#17 Amendment No. 2 to State of Florida Department of Environmental Protection Contract No. DC839 with Humiston & Moore Engineers, P.A. for professional services for the Honeymoon Island Beach Restoration Project decreasing the contract in the amount of \$166,750.00 approved; revised contract amount \$566,160.00 with 75 percent to be reimbursed by the State through an existing contract; Chairman authorized to sign and the Clerk to attest (Environmental Management).

Approval of Amendment No. 2 to the Florida Department of Environmental Protection (FDEP) Contract No. DC839 for Professional Services with Humiston & Moore Engineers for the Honeymoon Island Beach Restoration project.

AMENDMENT No. 02

Attachment A
Scope of Work

HONEYMOON ISLAND PHASE II SAV AND HARDBOTTOM SURVEY
FOR: PINELLAS COUNTY & DEP DIV. OF REC. & PKS.
DATE: 6/26/09 FILE: SEAGRASS SCALE: 1"=1000'
JOB: 13-005 DATUM: N/A FIGURE: 2

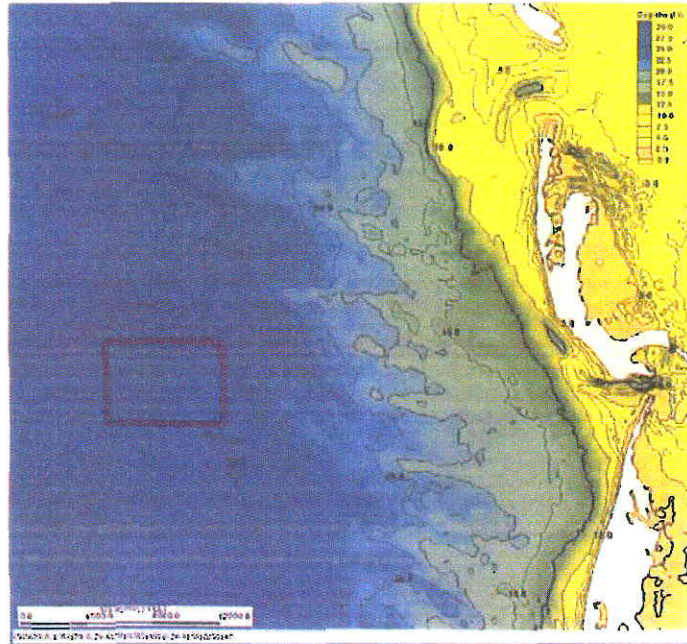
Environmental Assessment: An environmental assessment of submerged aquatic vegetation and hardbottom will be done within the proposed area of the nearshore region for Phase Two extending from R-7.5 to R-9.5 up to approximately 800 feet offshore (52 acres +/-). The same survey will also be done for the outer portion of the ebb shoal considered as a potential sand source for Phase Two along with the previous area dredged (75 acres +/-). Please refer to Figure 2. The first stage will involve a presence – absence survey and mapping of Submerged Aquatic Vegetation (SAV) communities. It is anticipated that this first phase will not find significant amounts of SAV in the areas identified in Figure 2. The second stage will quantitatively map and survey the existing SAV and hardbottom communities found within the areas evaluated that are also within 300 feet of anticipated dredging or construction of erosion control structures. This second stage of the environmental assessment of the project areas will include documentation of any seagrass and macroalgal species.
